Subject: Oconee Nuclear Station  
Docket Nos. 50-269, -270, -287  
Response to Request for Additional Information on  
the Oconee Emergency Power System

REQUEST FOR ADDITIONAL INFORMATION  
OCONEE EMERGENCY ELECTRICAL POWER  
DISTRIBUTION SYSTEM

Graphs of 3LP-17 Current During Test 4

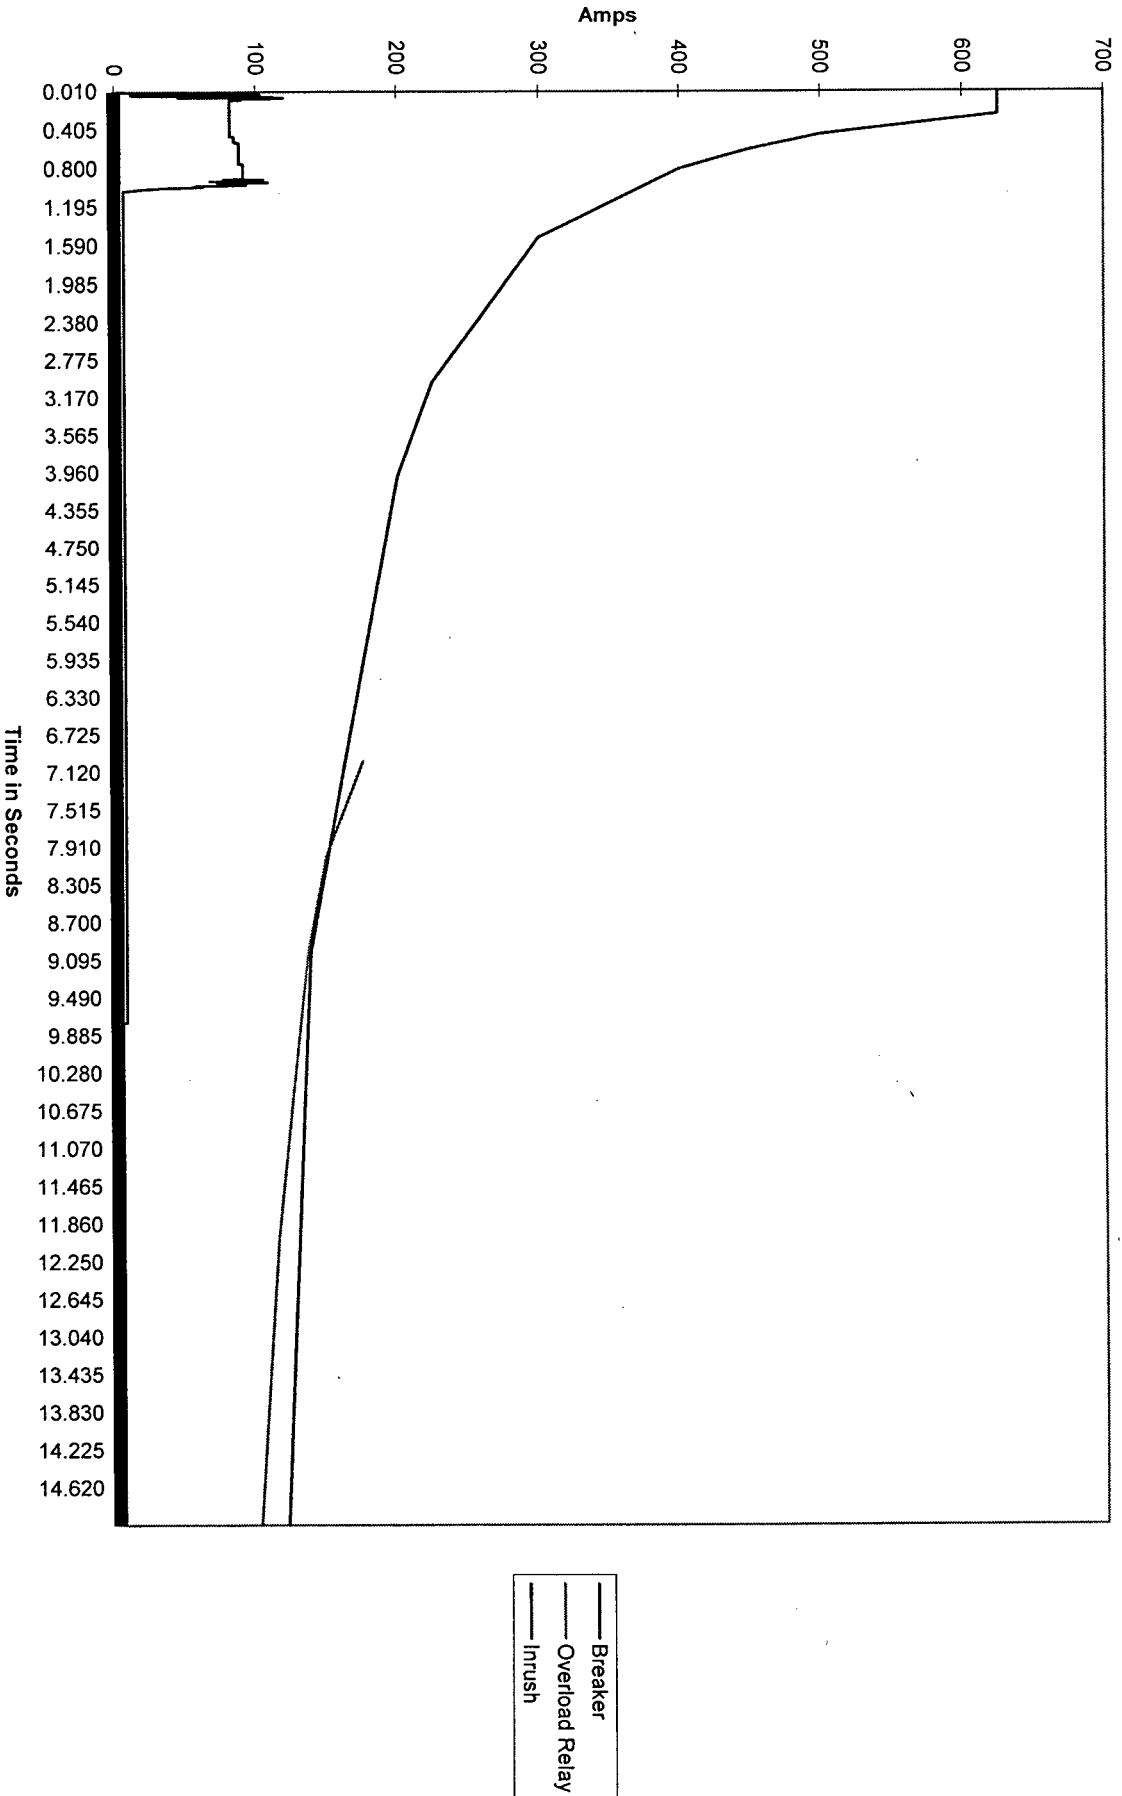
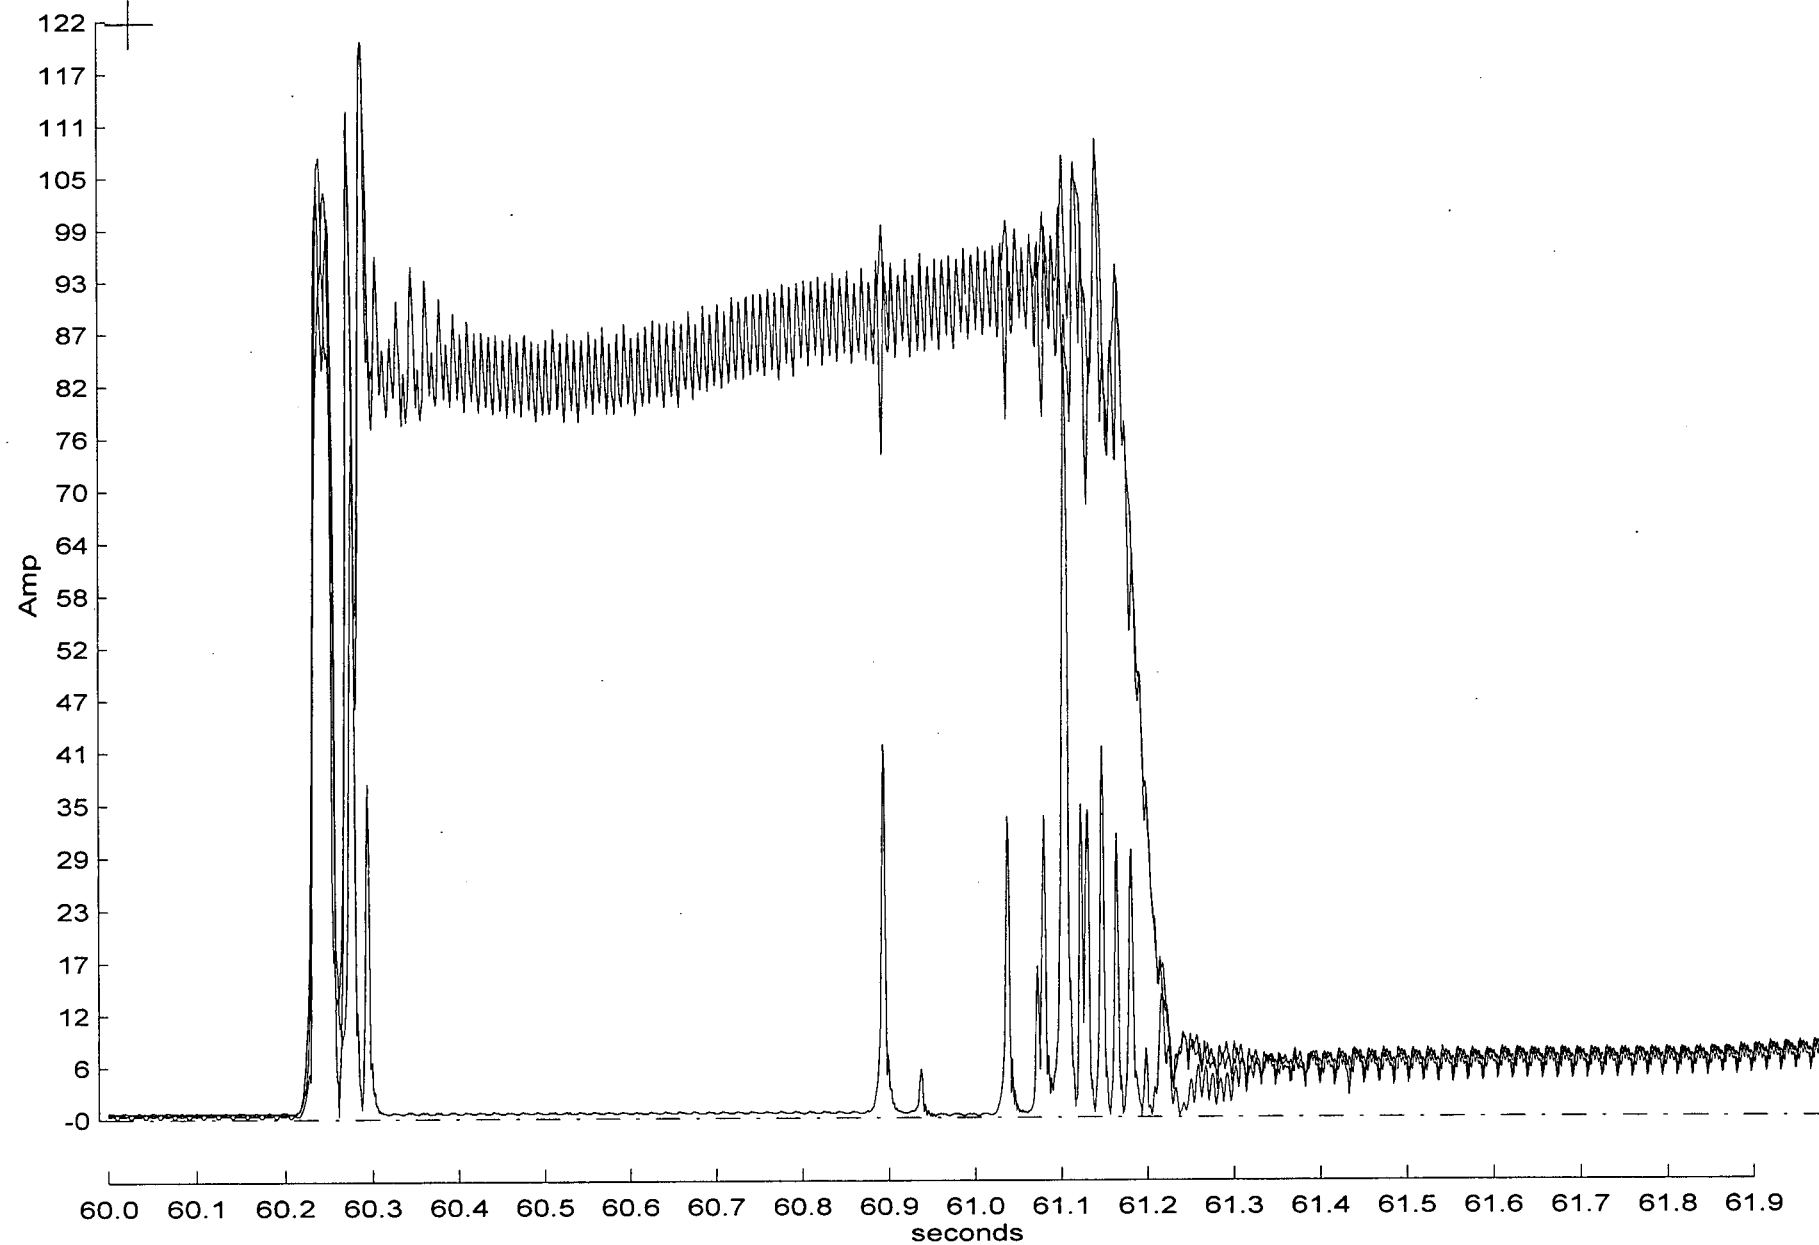
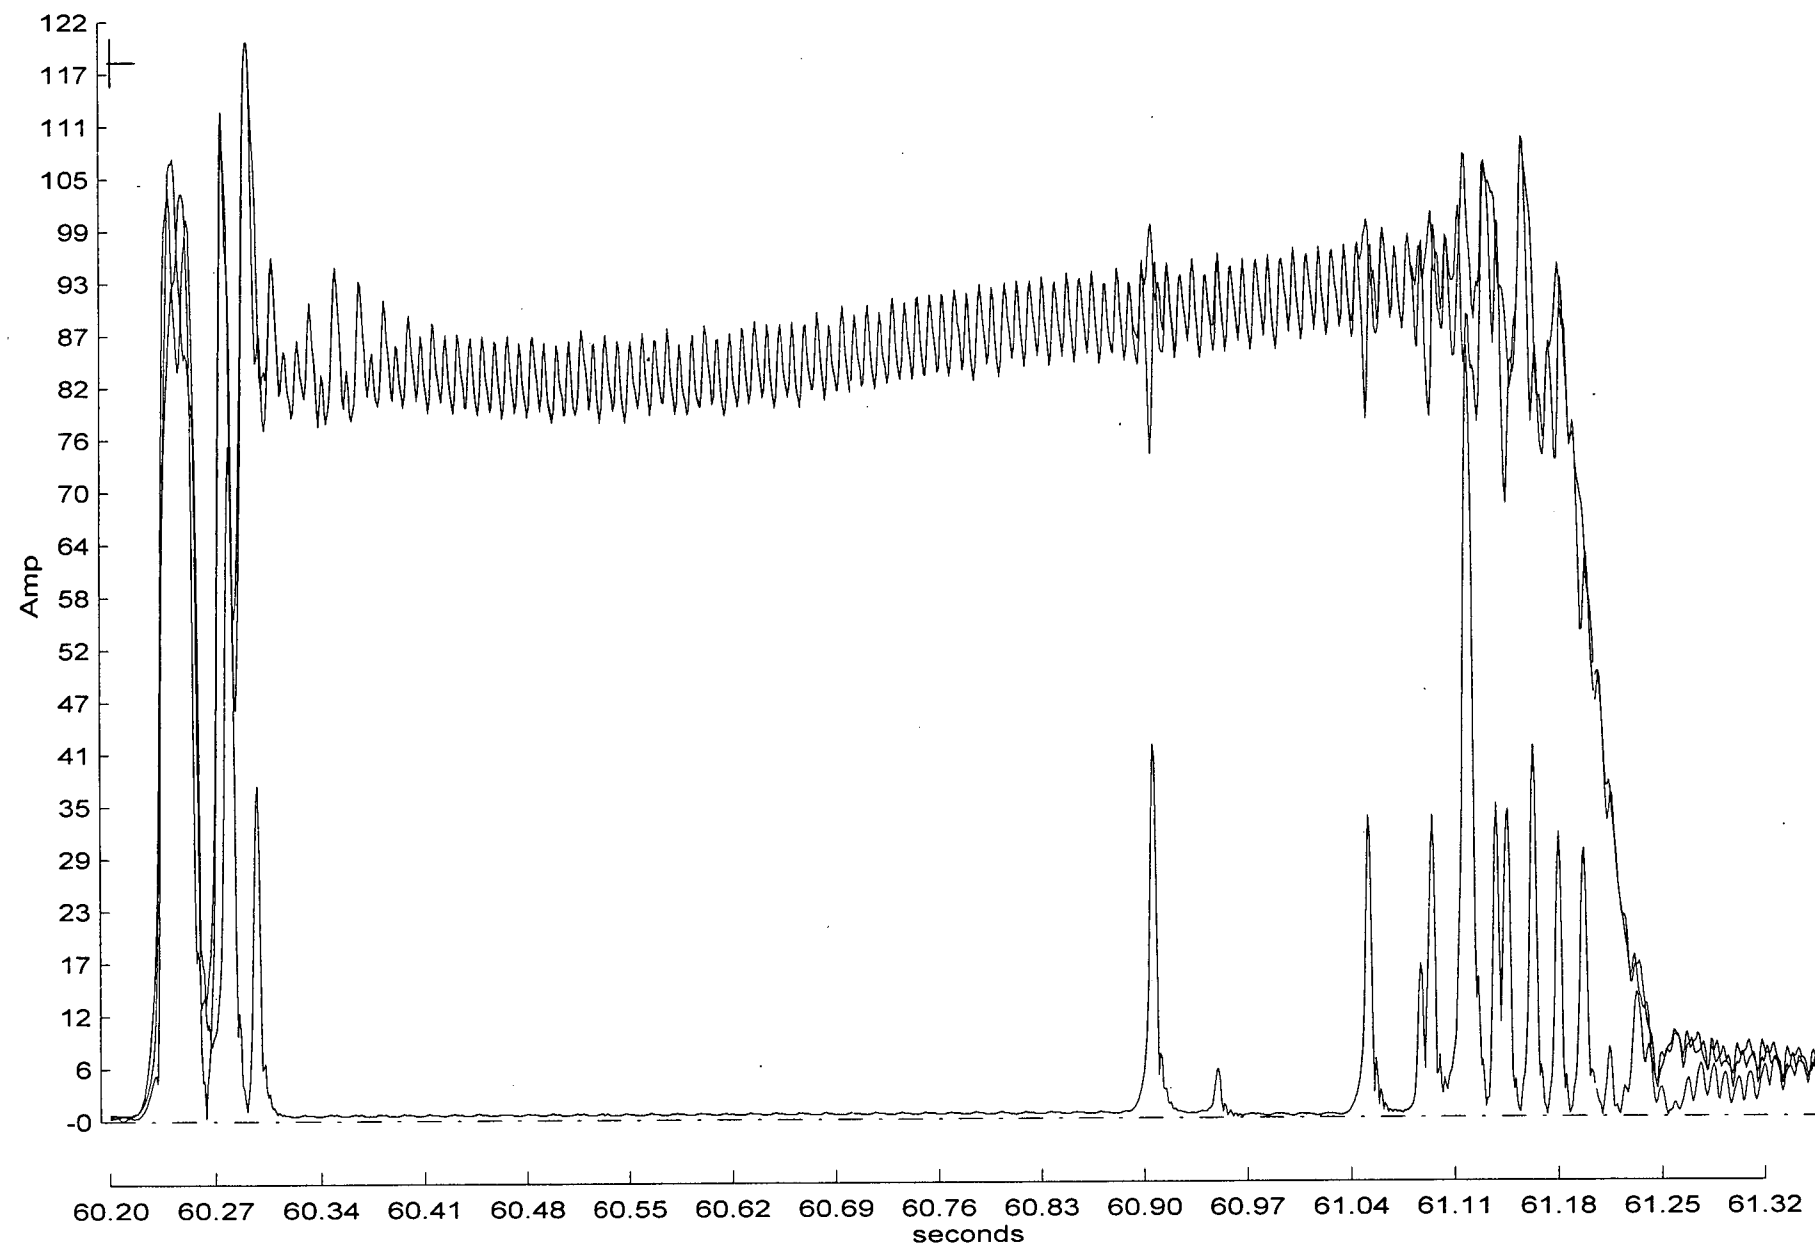
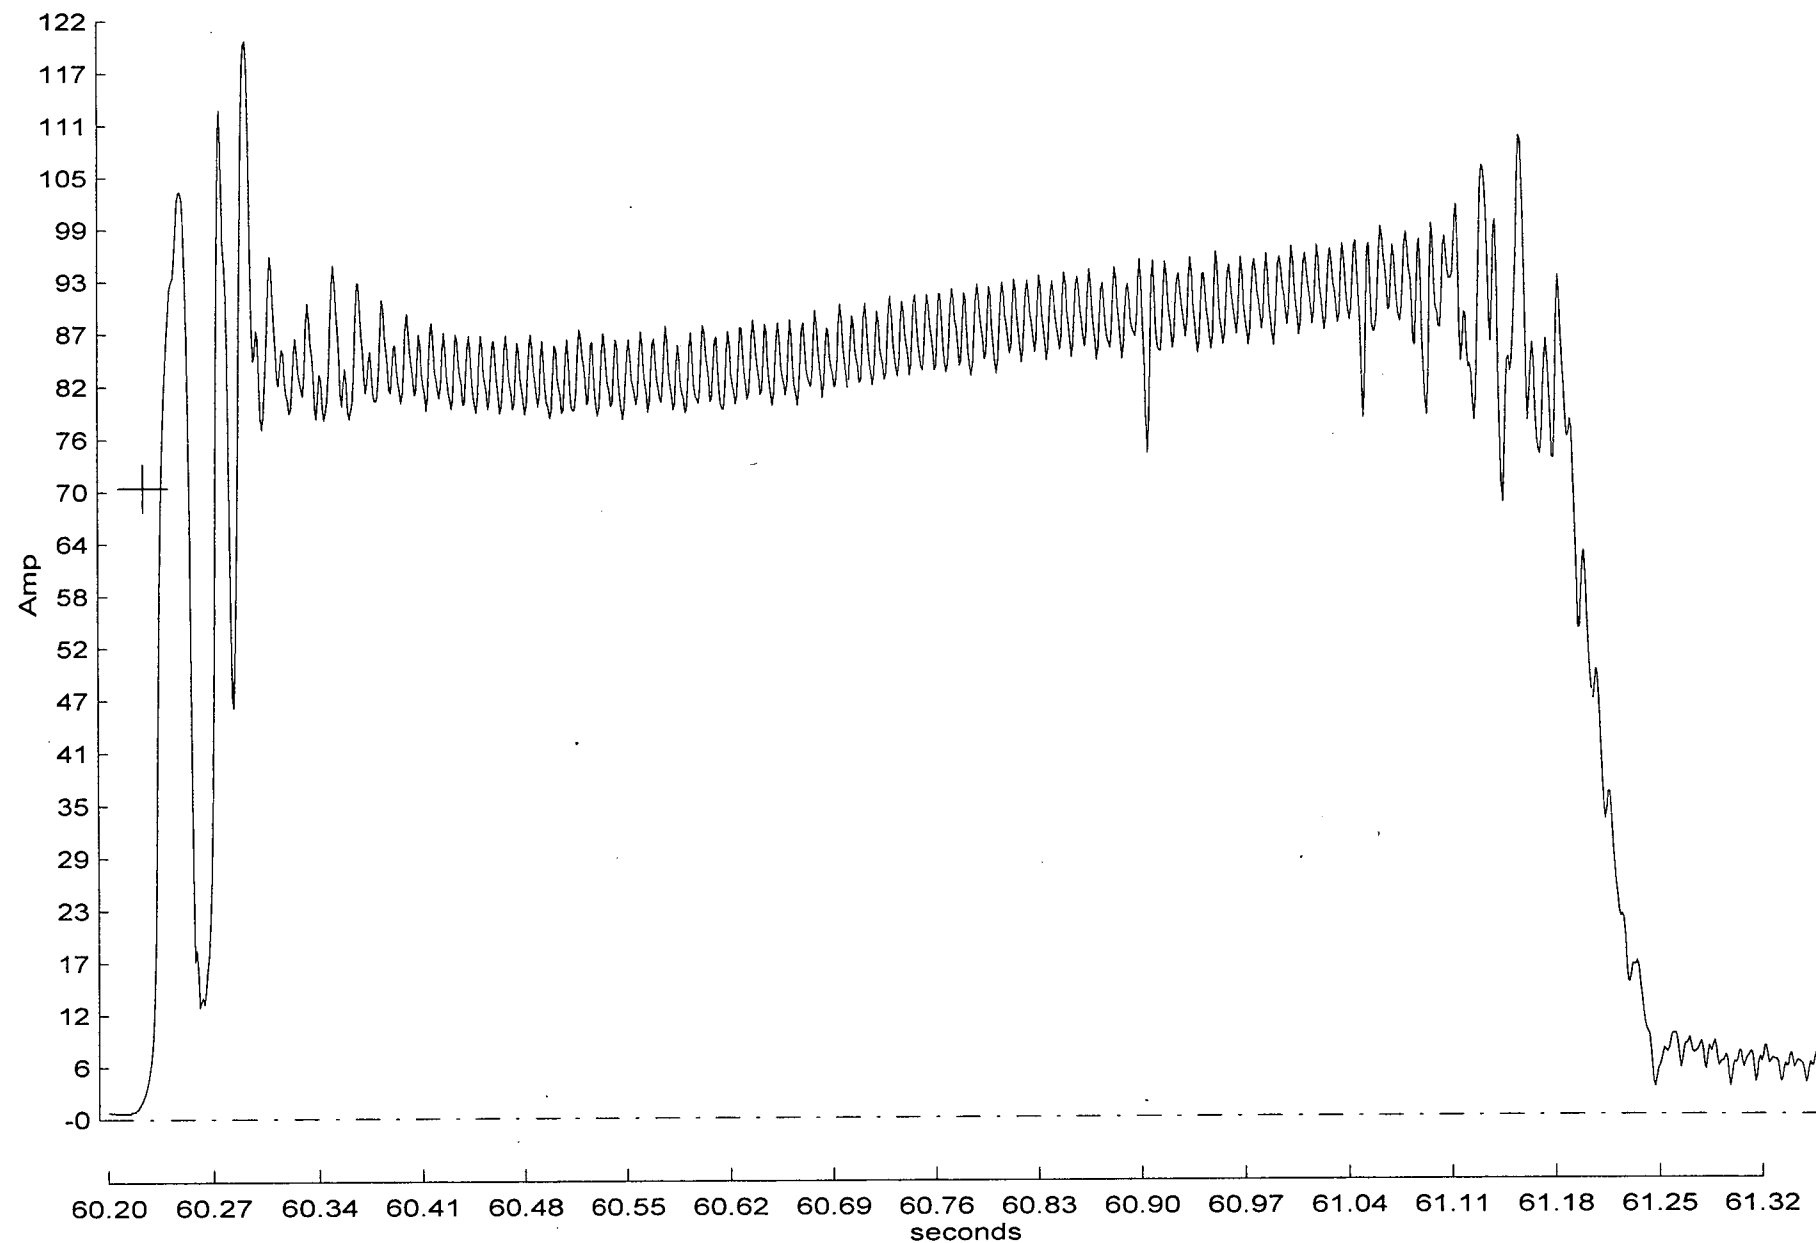
7. Section 5.2.4 of the report states that MOV 3LP-17, which is a gate valve, briefly stalled while starting following contactor pickup during Tests 4, 5, and 6. The stall times were 1.0, 1.0, and 0.4 seconds, respectively, for the three tests. The report indicates that the valve recovered in each case and completed its stroke to its proper ES position; and following inrush, valve stroke was normal and normal hammer-blow and unwedging was observed. We note that in all the LOCA tests where the MOVs are actuated, this particular valve's motor contactor picks up at a voltage value that is quite often one of the largest values seen on the group of valves that are monitored. On that basis, not considering any other variables, it would be expected that this valve would be the least likely to stall.

- d. Please provide plots of the valve motor's thermal capability and overload protection, overlaid on the starting inrush current figures shown for this valve during the tests.

monitored phases was analyzed for inclusion in the report since all valve stroke events could be identified regardless of which phase was analyzed. A more detailed review of the data for all three monitored phases indicates that the primary reason 3LP-17 appeared to stall was that the 'c' phase starter contact chattered while the 'a' and 'b' phase contacts maintained a stable energized state. Therefore, the 'a' and 'b' phases (one of which was included in the report) indicated stall conditions until the 'c' phase contact maintained a stable energized state. Once all three phases were energized, 3LP-17 stroked as expected. In retrospect, 3LP-17 did not actually stall as originally thought. Attachment 6 contains the plots of the current data for 3LP-17 which indicate the chattering of the 'c' phase contact.

Copies of the requested plots are contained in Attachments 2 through 6.
